**ADVISORY REPORT  
 FINDINGS, CONCLUSIONS, AND RECOMMENDATIONS**

**File:** **WOODINVILLE WATER DISTRICT KINGSGATE PUMP STATION,  
 FILE ZON12-00311**

# WOODINVILLE WATER DISTRICT PUMP STATION ZON12-00311

**GENERAL PROJECT SITE PLAN**  
 SCALE: 1" = 30'  
 FILE: 7763a10-010-101

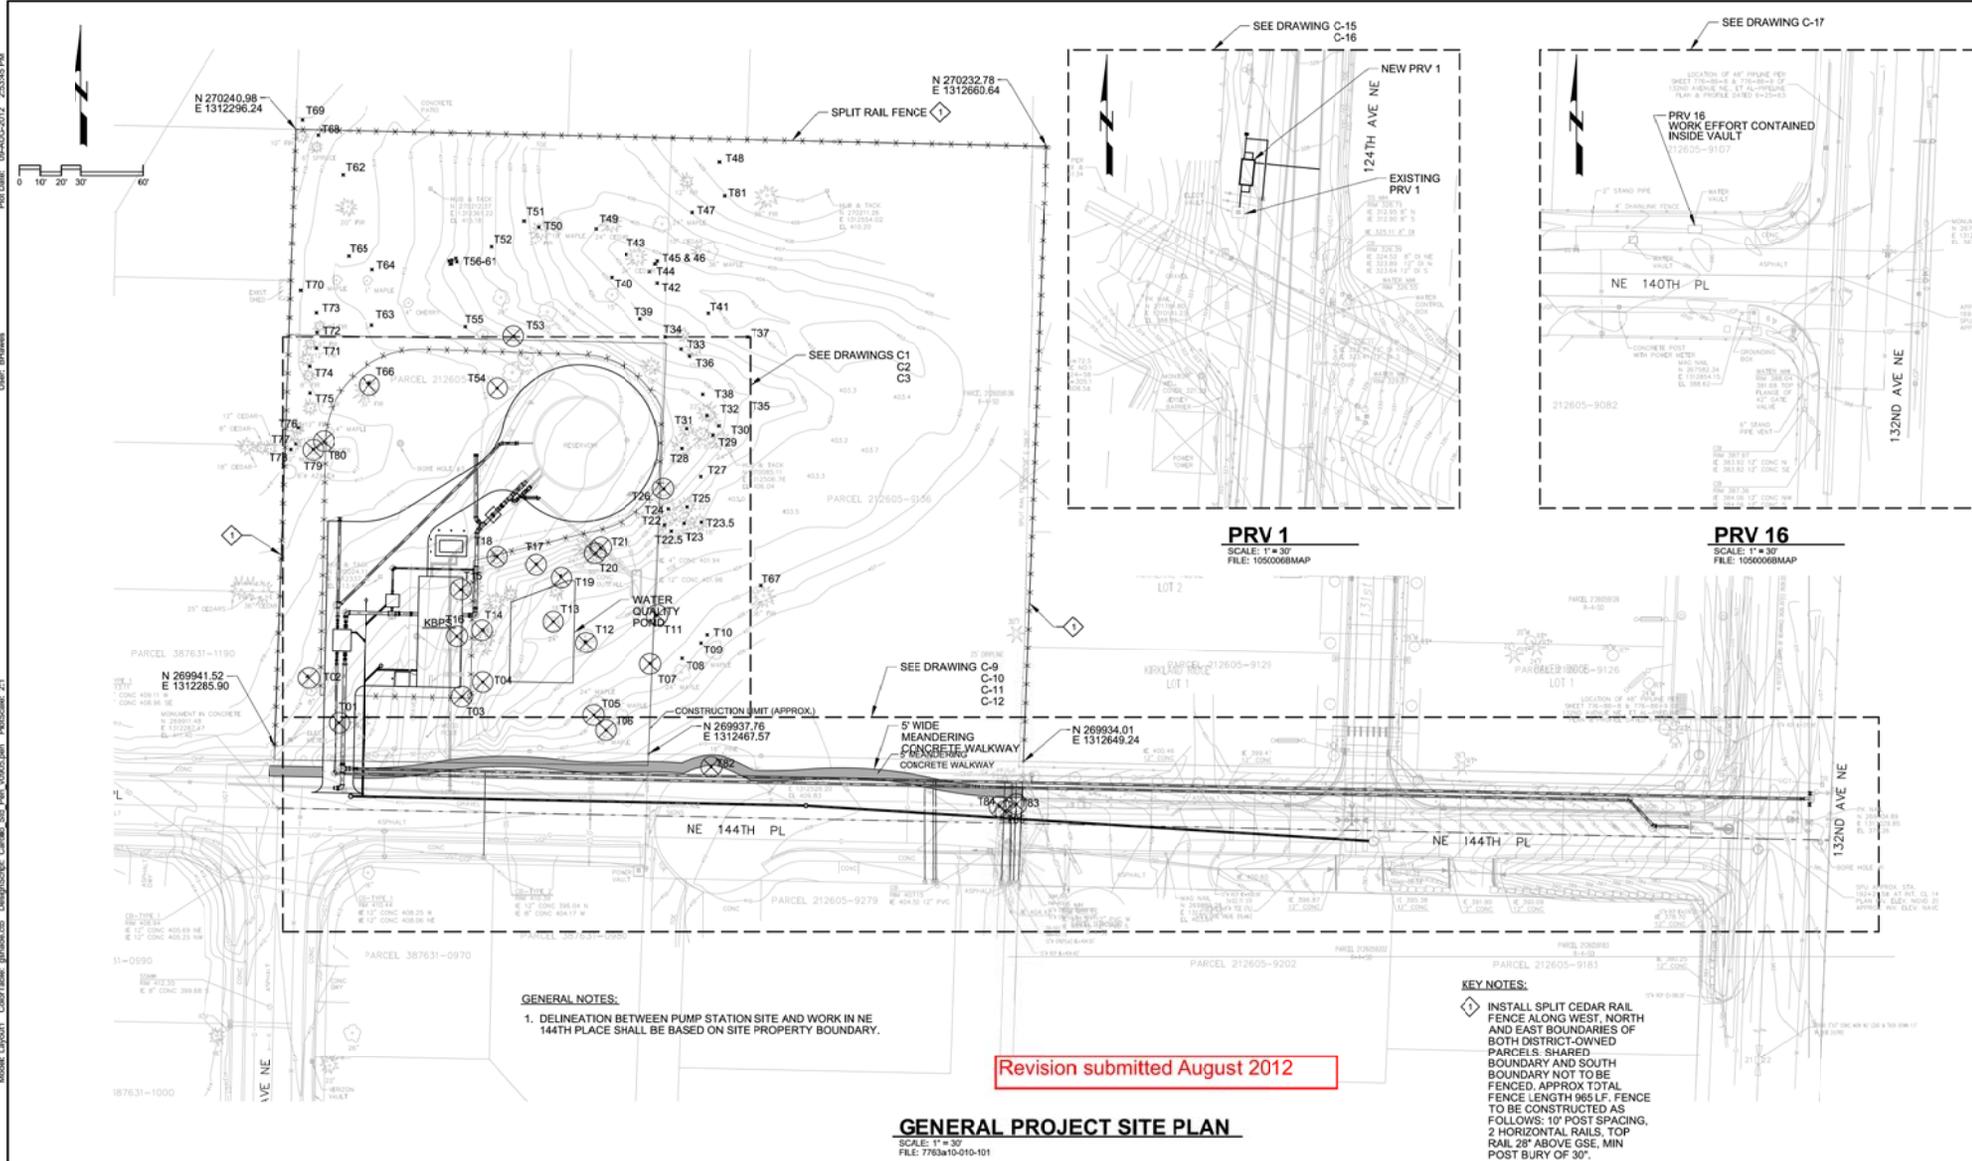
- b) Conclusions: The horizontal façade regulations apply to all proposed improvements located within 100' of the west, north, east and south property lines. The applicant is seeking a variance from KZC Section 18.08 to allow the building to be 54 feet in width and approximately 19 feet above average building elevation. See staff analysis in Section II.G below.

- (5) Based on the proposed new improvements to the site and the requirements of KZC 95.47, at a minimum, a 15' wide landscape buffer is required along the property line abutting two parcels on the west and two parcels across the street to the south.

The applicant proposes to meet this requirement by installing a 15' wide landscape buffer with trees and shrubs along the two parcels along the west and south property lines (see Attachment 4). A solid 6' tall fence is proposed along the east property line in back of one of the two parcels (because the other property currently contains a 6' tall fence). No fence is required along the south property line along the street.
- b) Conclusions: The proposal meets the minimum landscape buffer requirements and as a result will help minimize the visual impacts of the new public utility improvements on the surrounding residents.

- b) Conclusions: Pursuant to sections 110.10 and 110.25, the applicant should improve the right-of-way immediately adjacent to the subject property consistent with the standards set forth in Attachment 5 including meandering sidewalk and street trees.

3. As part of the application for a Building Permit the applicant shall submit:
  - a) A revised site plan indicating the required improvements described in Attachment 5 including paving, landscaping, street improvements and exterior lighting plans to minimize glare impacts on adjacent properties (see Conclusion II.E.)

4. Prior to occupancy, the applicant shall:
  - a) Install the required improvements as described in Attachment 5 and as follows:
    - (1) Right of way improvements within the NE 144<sup>th</sup> PI bordering the subject property (see Conclusion II.E.5).

- (2) Required landscaping shown on proposed landscape plan (and 6' tall sight obscuring fence along west property line of two lots) (see Conclusion II.E.3).
